SITE PLAN REVIEW AND APPEARANCE BOARD

Delray Beach Club

Meeting	File No.	Application Type
June 22, 2022	2022-143-SPI-SPR-CL2	Class II Site Plan Modification

Consideration of a Class II Site Plan Modification for landscape plan modifications and exterior color changes of the building for the existing Delray Beach Club, located at 2001 S. Ocean Boulevard.

Previously Approved Building Elevations

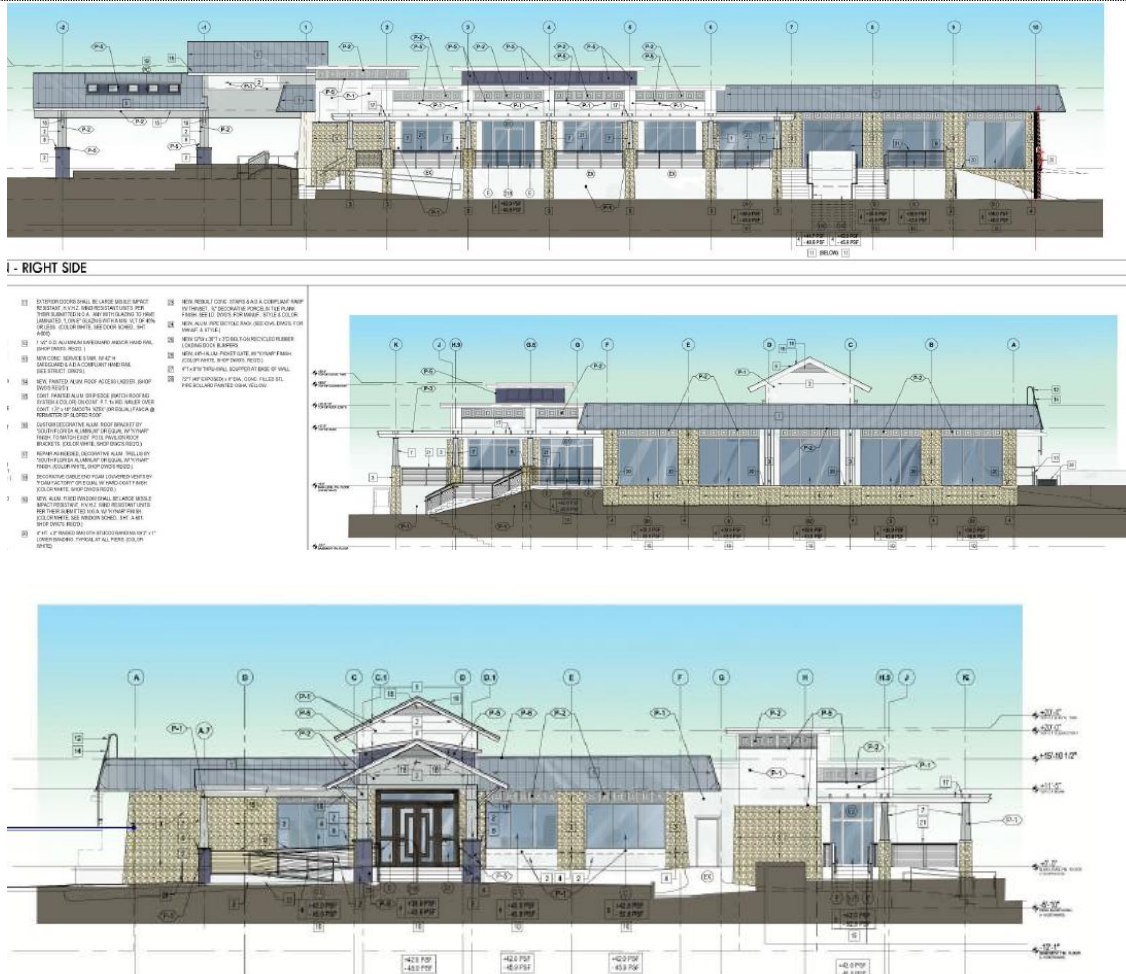
The applicant is requesting approval of a color change for the clubhouse buildings to include:

- “White Diamond” for walls,
- “Cumulus Cloud” for concrete beams,
- “Pure White” for louvers and fascia,
- “Black River Falls” for stucco headers and window sills.

A new standing seam metal roof in a galvalume mill finish is proposed. The existing native coral cladding will remain.

The proposal can be determined to be in conformity with good taste, good design; is not anticipated to cause the local/evolving environment to depreciate in appearance or value; and can be determined to be in harmony with development in the area and the Comprehensive Plan.
